DESIGN CRITERIA
FOR
HIGH TEMPERATURE LATTICE TEST REACTOR
PROJECT CAH-100
CHANGE #3

PROJECT CAH-100
HIGH TEMPERATURE LATTICE TEST REACTOR
DESIGN CRITERIA
CHANGE #3

This design criteria document is hereby changed and supplemented as described below. The paragraph reference(s) given for each item is considered to reflect that portion of the document that is most directly affected by the change, other paragraphs may also be affected.

① FRONT ELEVATION
240 VOLT CIRCUITS ARE INDICATED
LOCATIONS SHOWN ARE APPROXIMATE

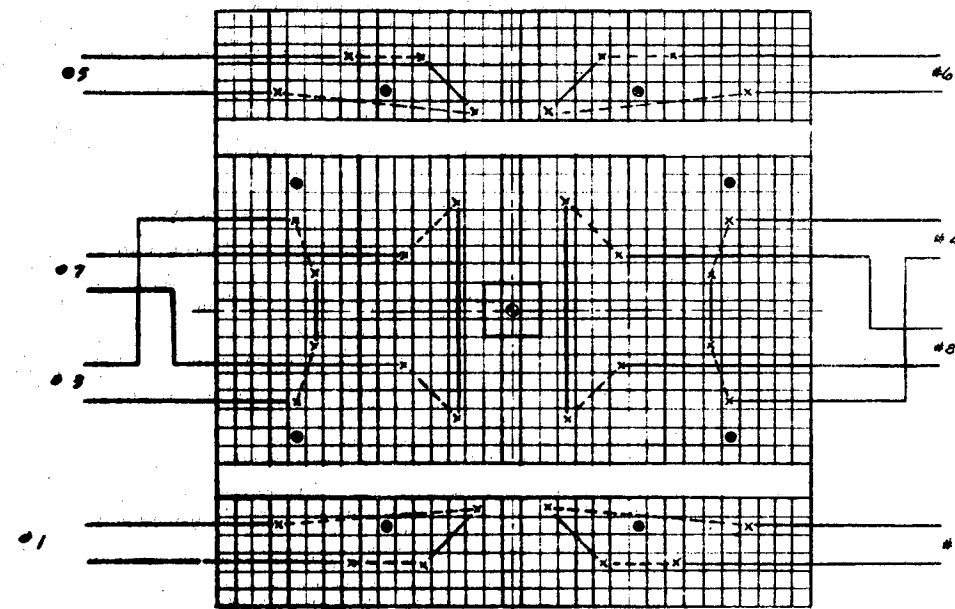
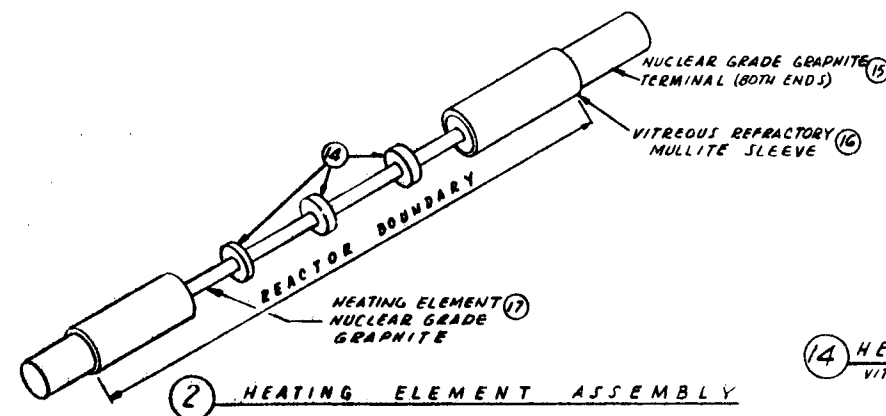
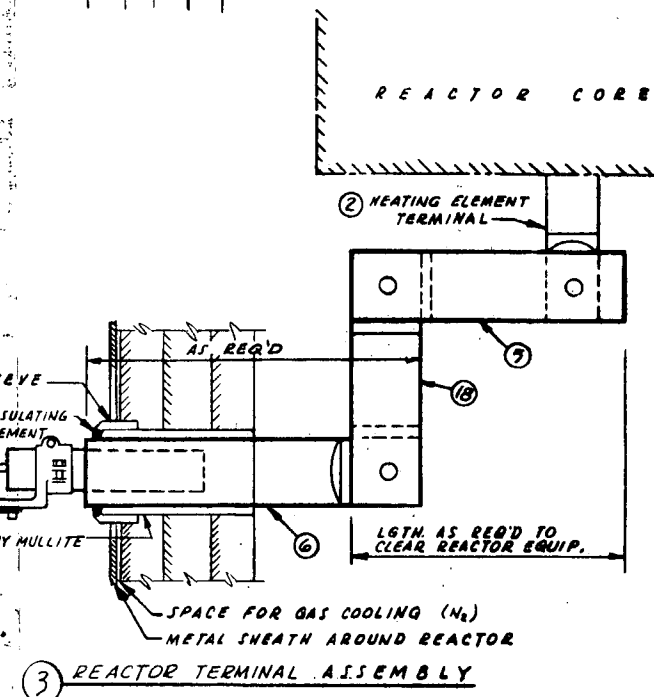
Change No. 3-D Reactor Heating Elements

Ref: Para. 5.1A In-pile heating elements. The description of a suitable heater system is modified to eliminate the use of insulators for supporting the heater elements within the heated zone of the reactor stack.
